UN Regulation No. 95 (Lateral impact)

Proposal for the 06 Series of Amendments to UN Regulation No. 95 (Lateral impact) *,**

Submitted by the expert from the International Organization of Motor Vehicle Manufacturers

Model A
(See paragraph 4.5. of this Regulation)

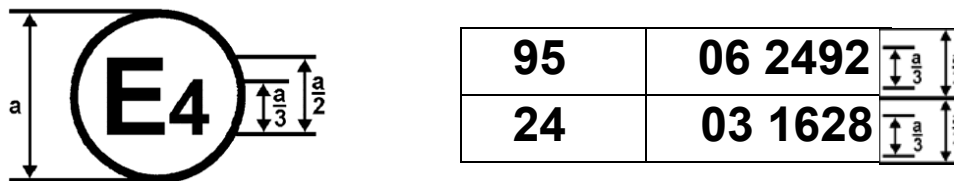
Annex 2, amend to read:

The above approval mark affixed to a vehicle shows that the vehicle type concerned has, with regard to the protection of the occupants in the event of a lateral collision, been approved in the Netherlands (E 4) pursuant to UN Regulation No. 95 under approval

number 061424. The approval number indicates that the approval was granted in accordance with the requirements of UN Regulation No. 95 as amended by the 06 series of amendments.
